STAFF RECOMMENDATION
1805 Fatherland Street
April 19, 2017

Application: New construction—detached accessory dwelling unit; Setback determination

Description of Project: Application is to construct a detached accessory dwelling unit (DADU) at the rear of the lot.

DADU SITE
PLAN
A0
04.03.17

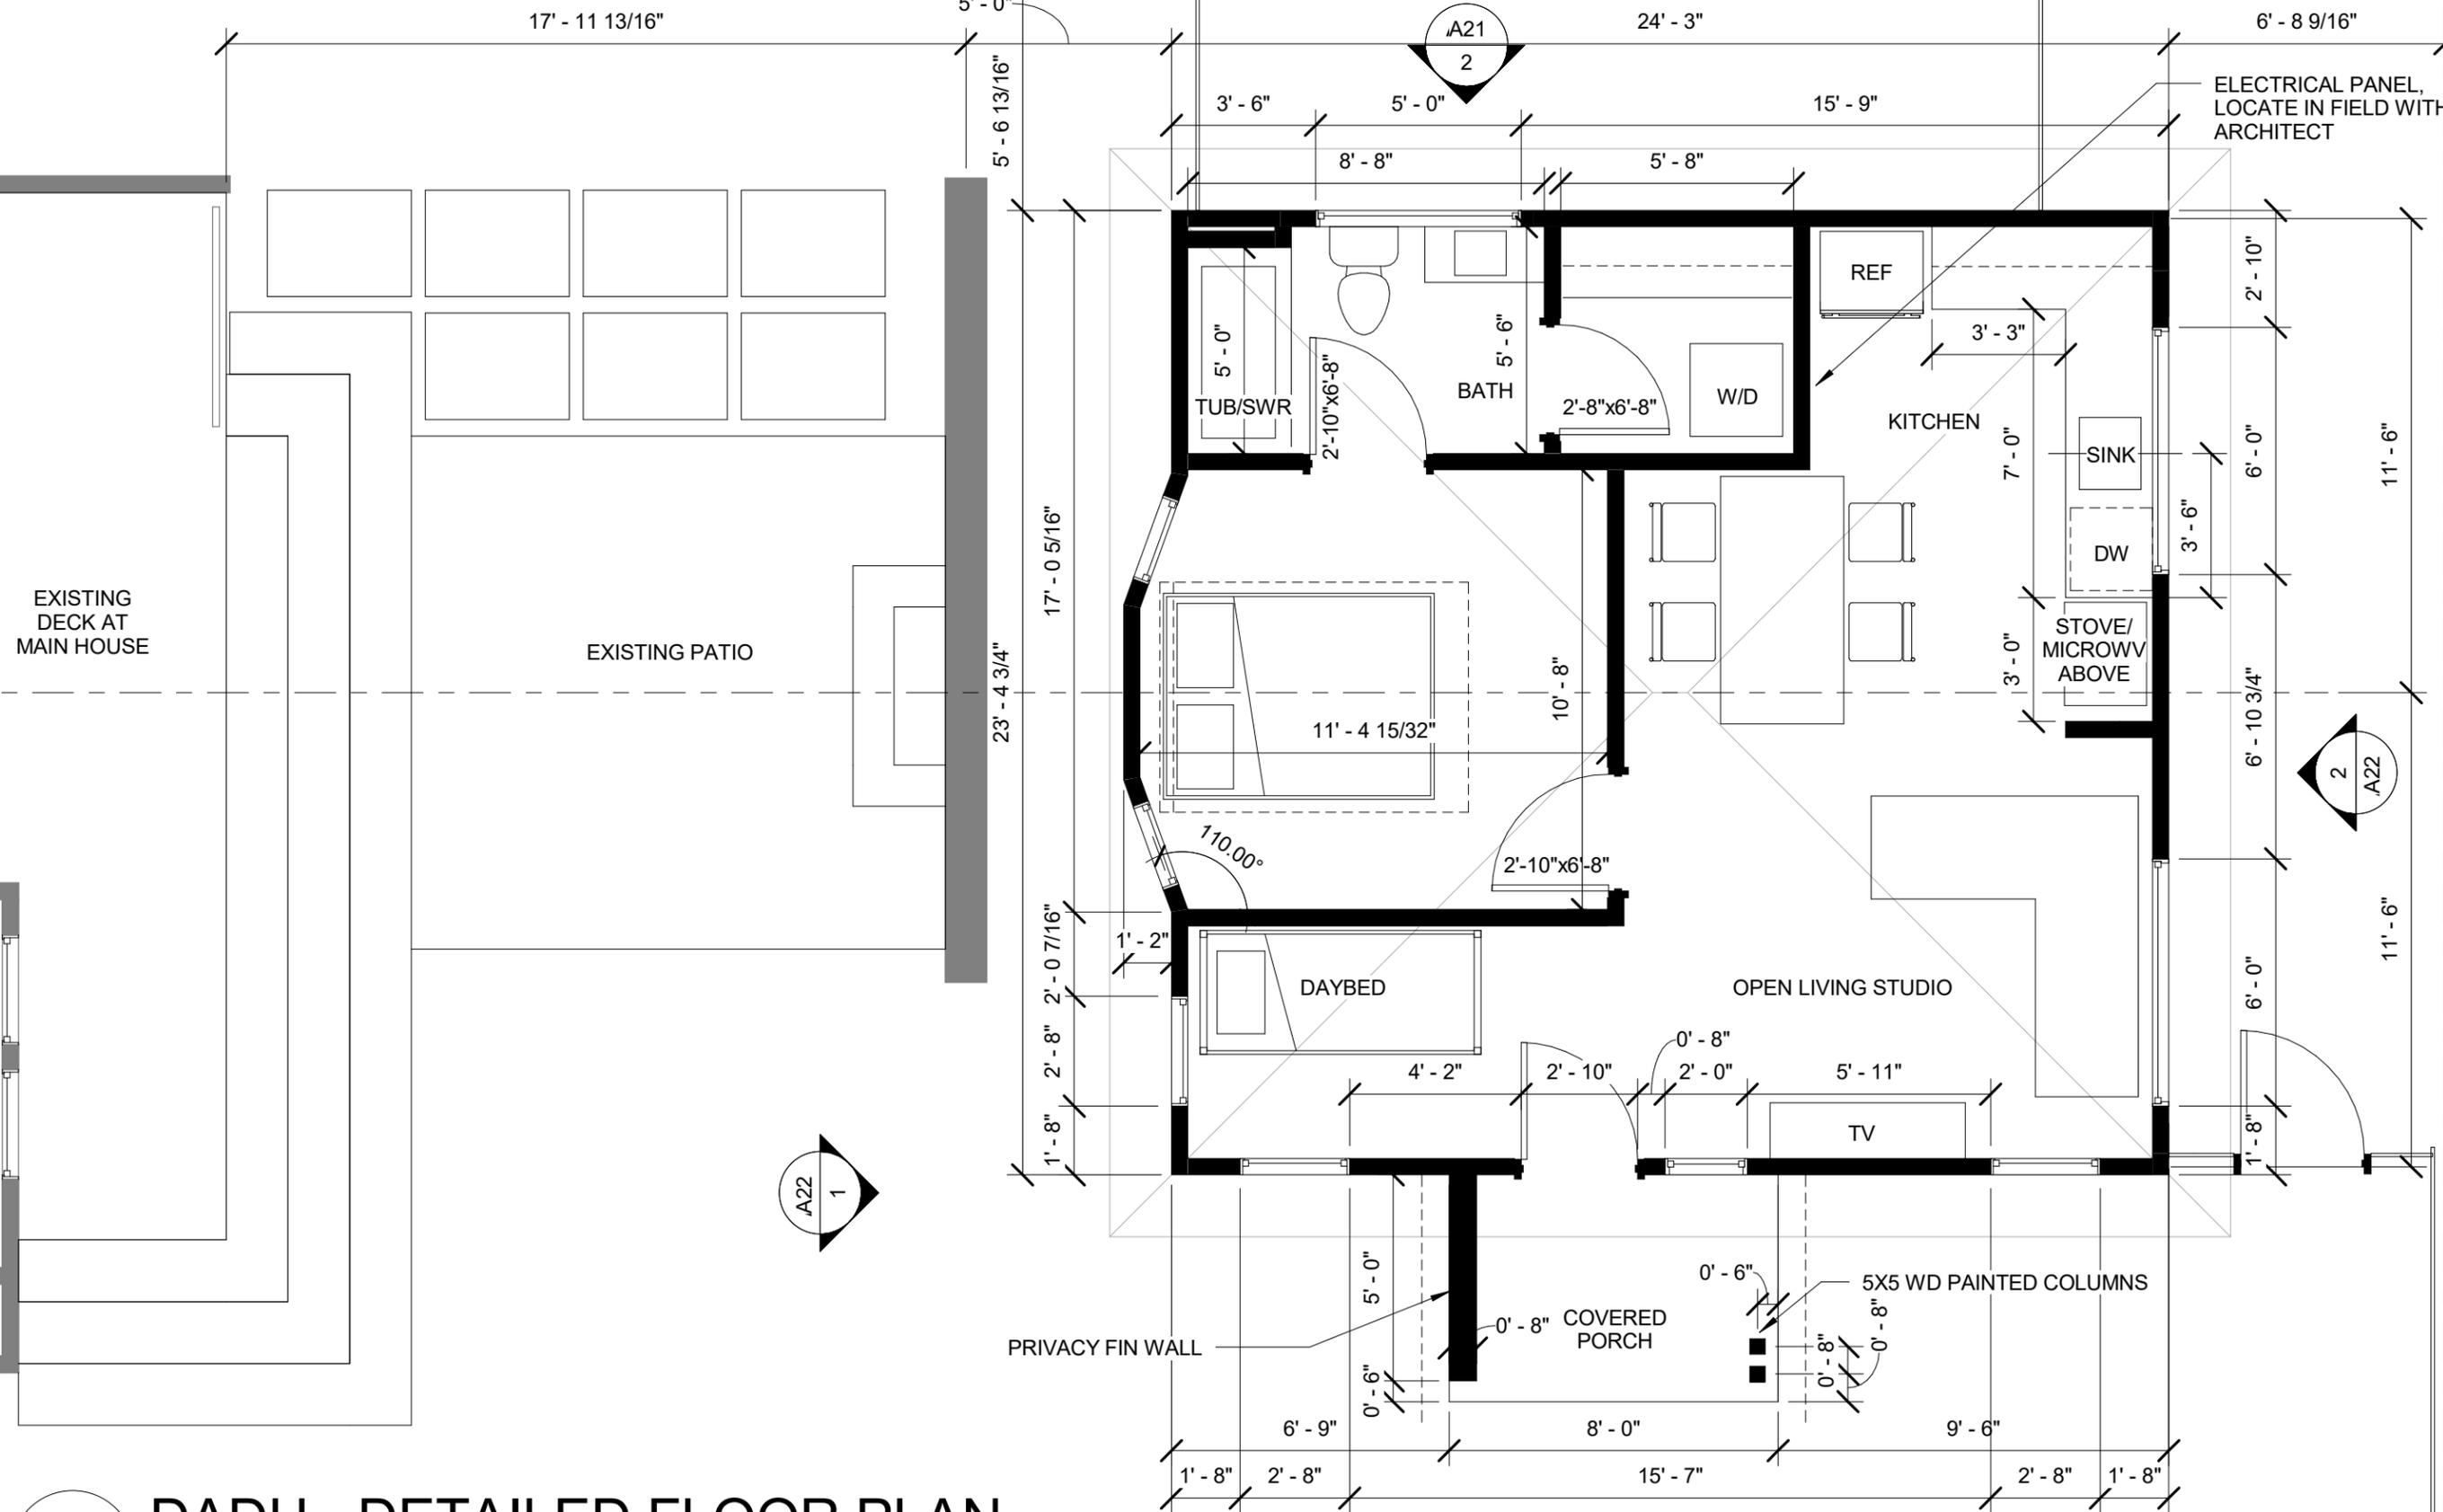
MINIMUM	PROPOSED
Space between principal building and DADU/Garage	20'	27'
Rear setback	3'	15'6"
L side setback**	3'	5'6"
R side setback**	3'	21'
How is the building accessed?	From the alley or existing curb cut	No vehicle door.

Staff finds that the DADU meets section II.B.8.b of the design guidelines and 17.16.30.G. 4 of the ordinance.

DADU ELEVATIONS
A21
04.03.17

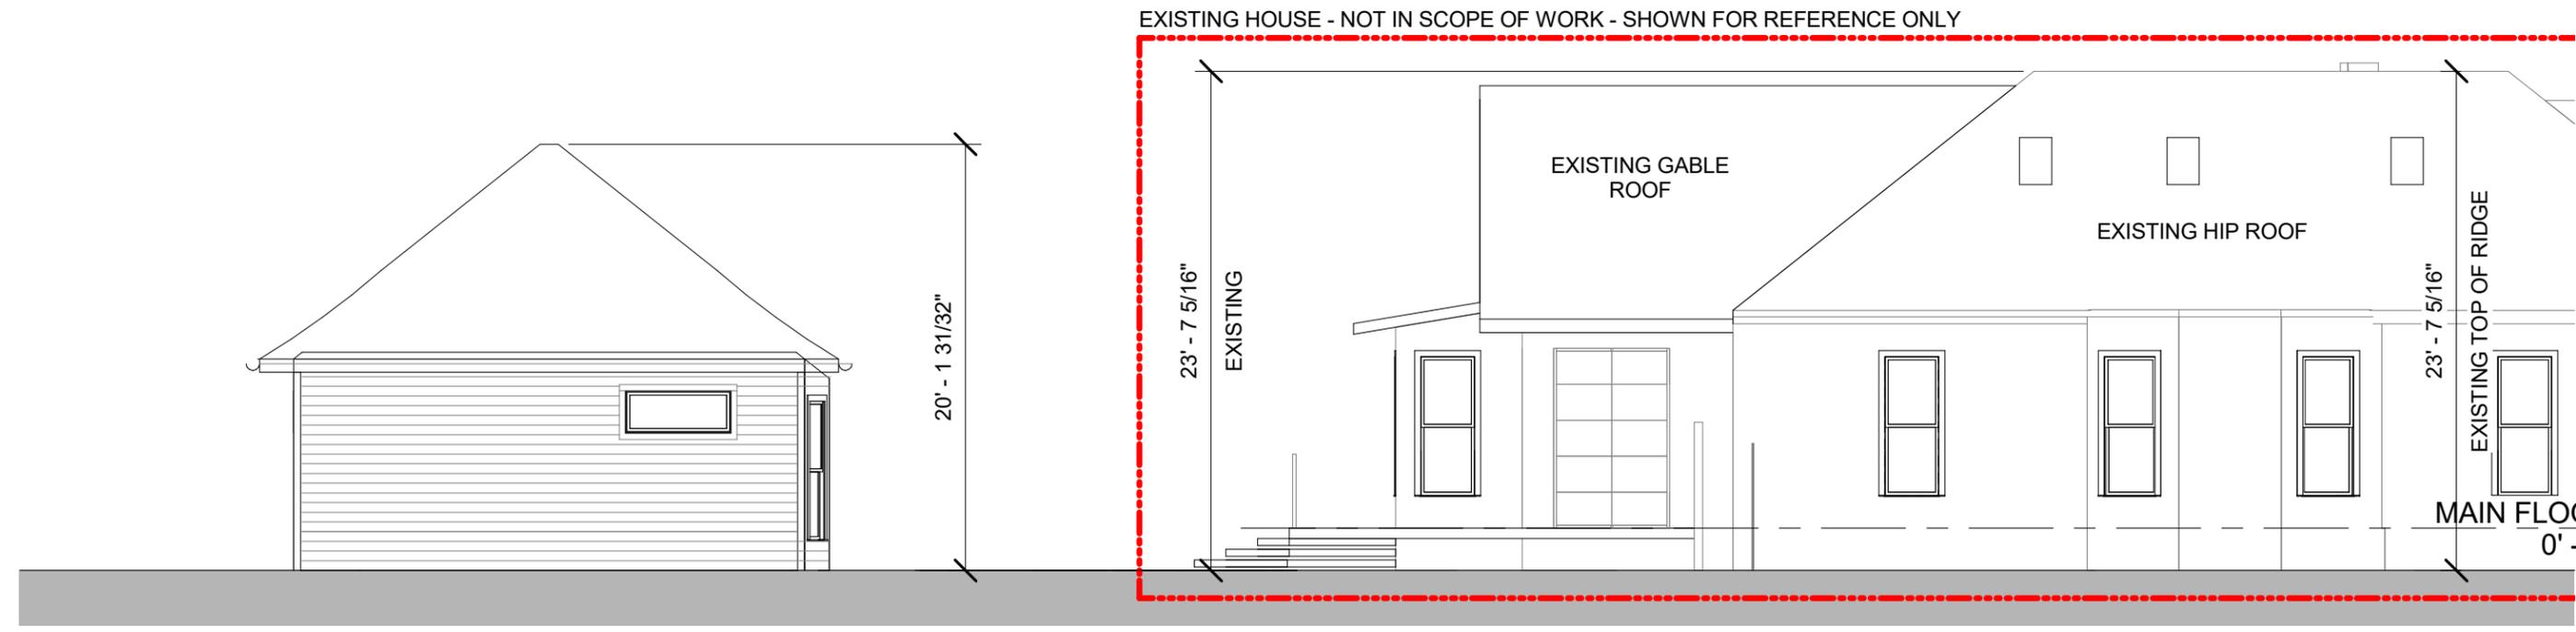
Proposed Element	Proposed Form	Typical of district?
Primary form	Hipped	Yes
Primary roof slope	9/12	Yes
Porch form	Shed	Yes
Porch slope	2/12	Yes

Since the roof form and slopes are similar to historic outbuildings, staff finds that the project meets Section II.B.8.a of the design guidelines and section 17.16.030.G.8 of the ordinance.

Design Standards: The accessory structure has a relatively simple design that is appropriate for outbuildings. Its roof form, detailing, and form do not contrast greatly with the primary structure. The fenestration is of a more modern layout, but is appropriate for an outbuilding. The DADU is in a minimally-visible location at the side and rear of the building. Staff finds that the DADU’s design meets section II.B.8.a of the design guidelines and Section 17.16.030.G.8 of the ordinance.

Existing conditions (height of historic portion of the home to be measured from finished floor)	Potential maximums (heights to be measured from grade)	Proposed (should be the same or less than the lesser number to the right)
Ridge Height	23'6"	23'6"	20'2"
Eave Height	11'6"	10'	10'

Staff finds that the DADU's massing meets section II.B.8.a of the design guidelines and 17.16.30.G. 7 of the ordinance.

1. Staff approve the final details, dimensions and materials of windows and doors prior to purchase and installation;
2. Staff approve the metal roof color; and
3. Staff receive a copy of the filed restrictive covenant for the detached accessory dwelling unit prior to issuance of a permit.
